#### **UNITED STATES ENVIRONMENTAL PROTECTION AGENCY**

Authorization to Inject into Two Class I Wells Located at the Environmental Geo-Technologies Facility in Romulus, Michigan, U. S. Environmental Protection Agency Permit Numbers: MI-163-1W-C010 and MI-163-1W-C011

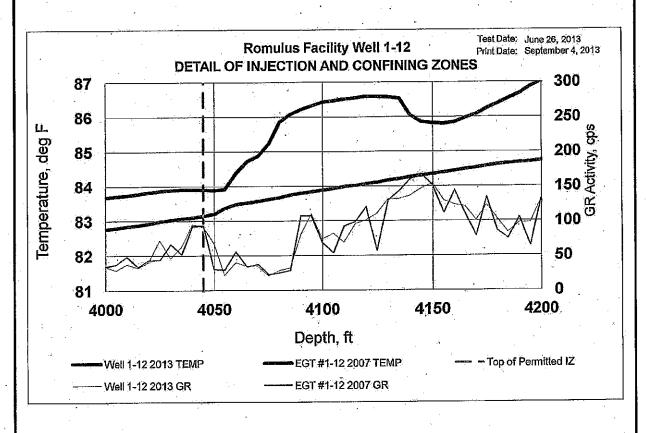
The 2013 test mirrors the 2007 test very well. There appears to be a sudden drop in temperature right at the start of the test, this is most likely caused by the hight temperature outside on the testing day. The other major difference is in the injection zone. In the 2013 test the curve remains constant after entering the injection zone. For the 2007 test there was a rise in temperature after entering the injection zone.

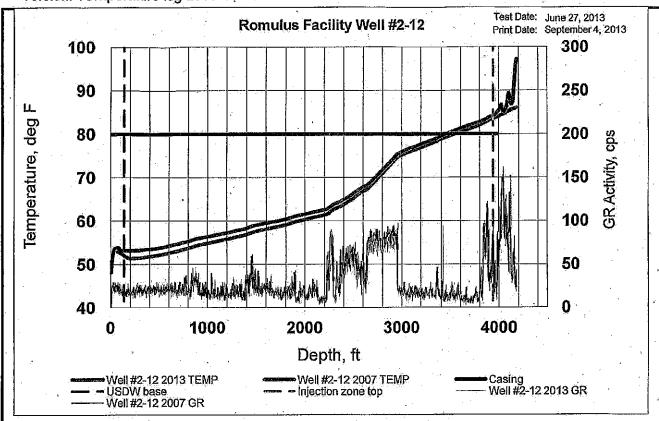
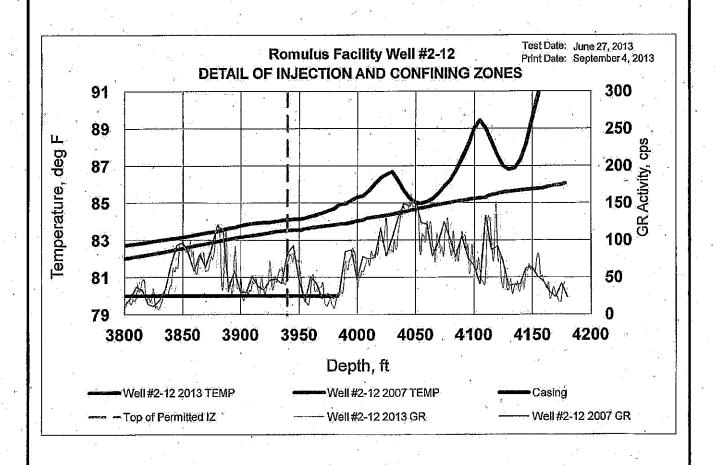
51.83	Not Apparent	51.35	51.83	
l op of Receptive Strata to top of IZ, fi NA	Thickness of Receptive Interval, ft			
· · · · · · · · · · · · · · · · · · ·	Analy	/sis	deren	
s a Log Available for Comparison?	Are traces Essentially Congruent?	Intervals with Constant Temp over n	nore than 50 ft. present in cased hole	
Yes	Yes	No		
What Well Log Used?	Is there a Pivot Point	Top of Interval #1, ft	Top of Interval #2, ft	
Well #2-12	No	<u>L</u>	<u>L</u>	
What Year?	If yes, What depth? ft	Bottom of Interval #1, ft	Bottom of Interval #2, ft	
2007	NA NA	NA NA	<u>L</u> NA	
	If Yes, What Temp? deg F	is Constant Temp More or Less that	1	
	NA NA	NA NA	i NA	
		Does this Suggest Flow?	Does this Suggest Flow?	
Company of the Compan		] NA	l NA	
Comments Before conducting the terprocedures.	st, the tool was tested in ho	t water as well as ice wat	er, per the submitted	
Doe	s the Well Have Exter	nal Mechanical Integ	rity?

Yes
